## **Reviewer one comments**

Adcock et al present a 12 year time series of O2/N2, CO2, and the tracer APO from a coastal background site in the UK. This is a unique, high quality dataset highly worthy of publication in ESSD. I recommend publication after some revisions. My main issue with this paper is that it is overly long without being detailed enough. At least half of the paper is devoted to an analysis of the dataset, which per the ESSD guidelines is not supposed to be included. This seems to come at the expense of detailed information on changes in the measurement system and technical issues, which are not fully described and could be of interest to anyone trying to actually use the data. My suggestion is to generate a complete list of calibration, target, and zero tank changes with IDs and assigned values (where applicable), and a complete change log or README type file where the major alterations to the measurement system are fully described, with exact dates. This shouldn't be too difficult to generate given the figures presented (i.e. the authors must have this information in hand to create the figures). There is a long paragraph of significant changes with approximate d

## Residuals before and after adjustment

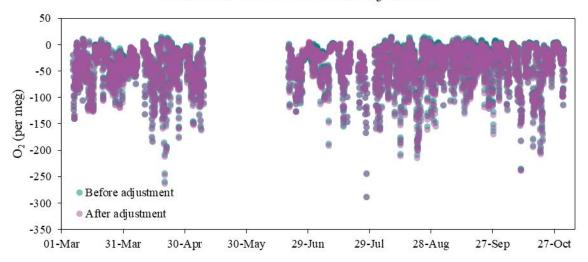
1. My last major comment is that the correction to the APO record is speculative at best. Forcing the WAO data to fit the CBA record is a creative approach, but the impact this has on the WAO data was not demonstrated. As I understand it it relies on the assumption that fractionation through a torn diaphragm was constant over shorter time scales, but not over several months. Is there any basis for making this determination? I understand the desire to salvage a significant chunk of data, and I think this is generally an OK approach, but the authors could have done more to convince me that it was reasonable. Could they perform the same baseline shift exercise on data which was not impacted at WAO and see how the residuals compare--do they have any structure? And what do the corrected vs uncorrected residuals look like? At the very least, this data should be better flagged in the data file--right now it is flagged as "2", which means "contact data provider". A separate flag for "corrected" or "baseline shifted" should be implemented.

We understand that the reviewer has some concerns about the adjustment applied to the 2018/2019 data. We hope that we can allay these concerns. Firstly, it is not uncommon to correct periods of data in this way, for example, Max Planck Institute for Biogeochemistry (MPI-BGC) used a similar method to adjust their  $O_2$  flask data after they discovered a leak in a valco valve (Rödenbeck et al., 2023). Secondly, we already provided detail regarding the quality control checks we carried out to ensure our pump correction was reasonable, as shown in Section S1 of the supplement. We used the Cold Bay Alaska data to apply the adjustment, and then used the Shetland Islands data to check that the adjustment was reasonable.

We have included a plot below of the data excluding baseline variability for the adjusted-leak data and for the 9 months after the leak, to show that the variation excluding the baseline is similar for both time periods.

We have also included a plot below showing the data excluding the baseline for the leak period, before the adjustment was applied and afterwards, to show that the variation excluding the baseline is similar in both cases.

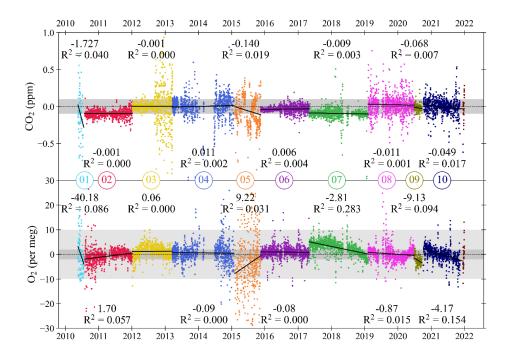
13. Fig 4: Isn't the target tank a measure of the repeatability, not the compatibility? If so, the shaded bands should be half the compatibility goal as pointed out on L263.

The TTs are used both to measure the repeatability and the compatibility. The compatibility is how much in agreement the measurements at WAO are to the UEA CRAM Laboratory over both long and short-term timeframes, where TT cylinders are usually analysed before being used at WAO. In Figure 4, the UEA CRAM Laboratory values are zero on the y-axes, so Figure 4 is showing the compatibility of the TTs, and therefore the shaded band is the right size. The repeatability is calculated using the mean of  $\pm 1\sigma$  standard deviations for every two consecutive 2-minute averages for each TT run. So, the repeatability can be thought of more as a measure of short-term reproducibility under the same conditions. The repeatability is shown in Table 2.

We are using the definitions of compatibility and repeatability that come from the 20th WMO/IAEA Meeting on Carbon Dioxide, Other Greenhouse Gases and Related Measurement Techniques (GGMT-2019), Global Atmosphere Watch (GAW) Report: compatibility is a measure of the persistent bias between measurement records; and repeatability is a measure of the closeness of the agreement between the results of successive measurements over a short period of time (Crotwell et al., 2020).
